App'n. Serial No. 10/721,895
Filed: November 26, 2003
Docket No.: 8932-803-999
CAM No.: 232200-999210

REMARKS

Amendment Dated Feb. 28, 2006
Reply to Nov. 28, 2005 Office Action
Annotated Drawing Sheet Showing Changes

Fig. 1

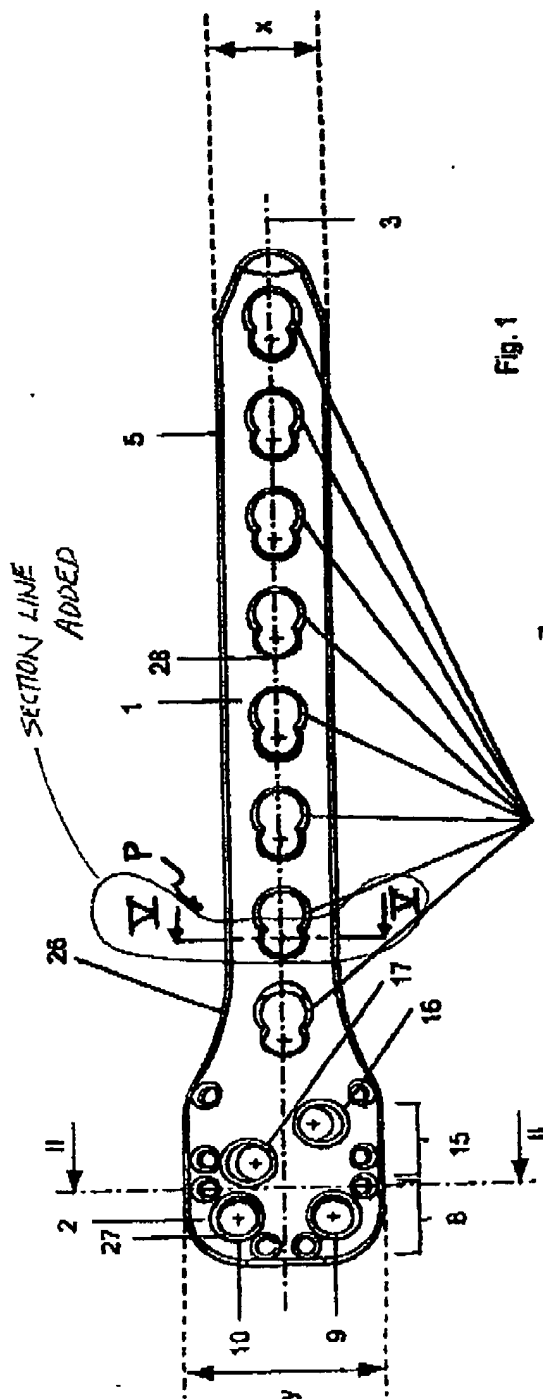
The attached drawing sheets include an amendment to FIG. 1 and a new FIG. 5. The first sheet includes FIGS. 1 and 2 and replaces the original sheet that included FIGS. 1 and 2. In FIG. 1, a new "section" line, labeled "V-V," has been added. The second drawing sheet includes new FIG. 5, and depicts a cross-section through the bone plate along line V-V, shown in amended FIG. 1. The attached APPENDIX includes a clean replacement Sheet containing FIGS 1 and 2, a clean new sheet with FIG. 5, and an annotated copy of the sheet containing FIG. 1, showing changes.

The Examiner has objected to the drawings as not showing the "double threaded" hole recited in claims 5 and 34. (Nov. 29, 2005 Office Action in Appln. Ser. No. 10/721,895 at 2 (hereinafter, "the Office Action").) In response, Applicants have added new FIG. 5, which is a partial cross-section taken through the bone plate shown in FIG. 1, to more clearly show the recited double threaded hole. Applicants have also amended FIG. 1 to include a new section line "V-V," which corresponds to the cross-section shown in FIG. 5. These drawing changes are fully supported by the originally-filed specification. No new matter has been added. Applicants respectfully request approval of amended FIG. 1 and new FIG. 5, and submit that these drawing changes obviate the objections to the drawings.
